This petition filed under 37 C.F.R § 1.181 is in response to the Advisory Action mailed on September 23, 2003. Applicants respectfully request that the Examiner's comments and objections in the Advisory Action be withdrawn, stricken or otherwise corrected on the basis that they are legally and factually erroneous and go beyond the Examiner's scope of authority.

Patent Application for: FULL WRAPPING DISPOSABLE REFASTENABLE AND ADJUSTABLE PANT
 Inventor(s): Datta et al.
 Attorney Docket No.: 659-829 & Kimberly Clark Ref. No. 14-104-1

Fig. 1A

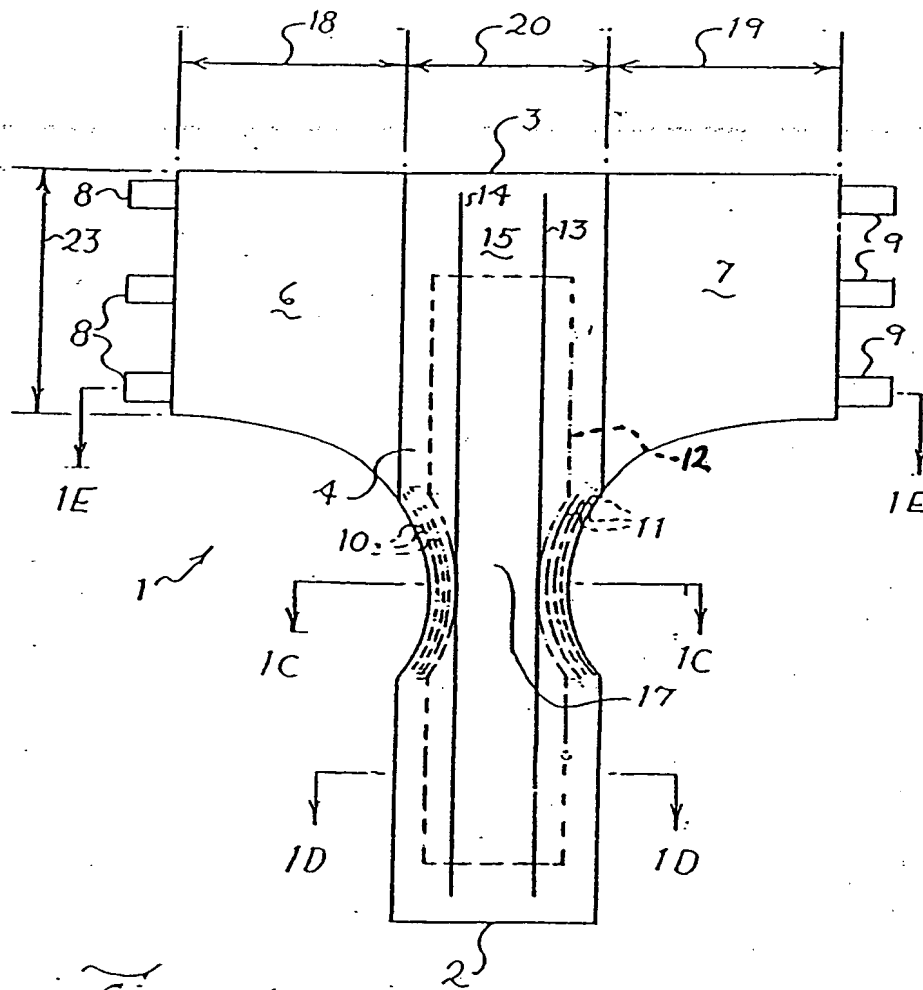
The drawings are objected to because in Figure 1A, the top layer of the chassis designated 15 and 12 and the absorbent pad is not designated 12. Element 5 in Figures 1B and Figure 2 are not consistent. Element 1 shown in Figures 1A and 1B and that in Figure 3 are inconsistent. A proposed drawing correction or corrected drawings are required in reply to the Office Action to avoid abandonment of the application.

Applicants have amended Figure 1 so that 12 now appear with dashed lines to indicate that it is underneath 15. Figure 2 and the corresponding disclosure in the specification have been amended to change the designation for the front panel from 5 to 51. In figure 5 the outer member serves as the fastening panel. Support for this embodiment is expressly found at page 4, line 2, and in the drawing of figure 2, as originally submitted. (Designation 51 is not used in any other figure). Plaintiffs have amended Figure 3 and the corresponding text in the specification to change the designation from 1 to 111. (Designation 111 is not used in any other figure). Thus, Applicants have overcome the objections to the drawings set forth in Item 4.

Figure 2 Drawing (Amended 9-30-02)

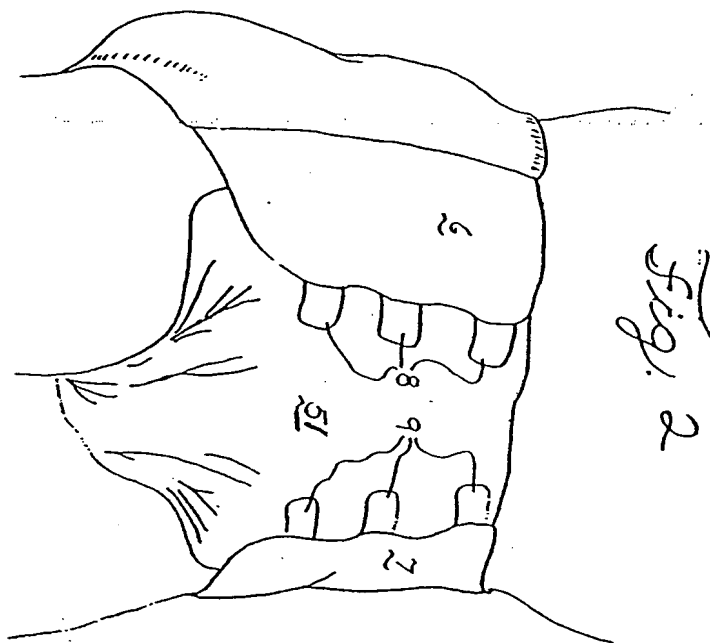
The proposed drawing correction and/or the proposed substitute sheets of drawings, filed on 9-30-02 have been approved in part (Figures 1A and 3 only). A proper drawing correction or corrected drawings are required in reply to the Office action to avoid abandonment of the application. The correction to the drawings will not be held in abeyance. . . **The drawing change proposed for Figure 2 was not approved because such gave two different designations to the same front end fastener.**

The drawings are objected to because element 5 in Figures 1B and 2 are not consistent, i.e. a square like that shown in Figure 1B should be labeled 5 in Figure 2. A proposed drawing correction or corrected drawings are required in reply to the Office action to avoid abandonment of the application. The objection to the drawings will not be held in abeyance.

With regard to Item 3 and Item 5, second full paragraph, the understanding of the invention is based on the disclosure of the invention in the specification. Applicants have not described the front fastening panel in Figure 2 as being a different embodiment nor pointed out such at the disclosure on page 4, line 2, which line is a description of the fastener 5. The Examiner's objection to the proposed Figure 2 in paragraph 2 of the FINAL, the objection to the originally filed drawings in paragraph 3 of the FINAL and the objection to the original specification as amended 9-30-02 in paragraph 4, item 2), of the FINAL are based on such description. If Applicant maintains the request to have Figure 2 approved as proposed 9-30-02 the nature of the invention shown in Figure 2 would be much clearer if on page 4, line 2, after "panel", --, see 51 in Figure 2 -- could be inserted.

The Examiner's objection to the amendment to Figure 2 shows a fundamental misunderstanding of Applicants' invention, the disclosure in Applicants' specification and Item 4 of Applicants' September 30, 2002 Response. A separate patch of material to serve as a landing member is not part of the embodiment shown in Figure 2. Thus the closure mechanism of Figure 2 works without the need for a separate patch of material, i.e. the patch of material shown as number 5 in Figure 1D is not needed nor intended to be in Figure 2. Moreover, support for the drawing of Figure 2, without a separate patch of material, is expressly found at page 4, line 2 of the specification, which provides: "[a]lternatively, an outer member may serve as the fastening panel." Thus, contrary to the Examiner's assertion, a drawing of Figure 2 is not required or intended to have a "separate square like that shown in Figure 1B." Such a separate square is not needed for the closure mechanism to function. . . Accordingly, amended Figure 2, which does not show a separate material, is correct as drawn.
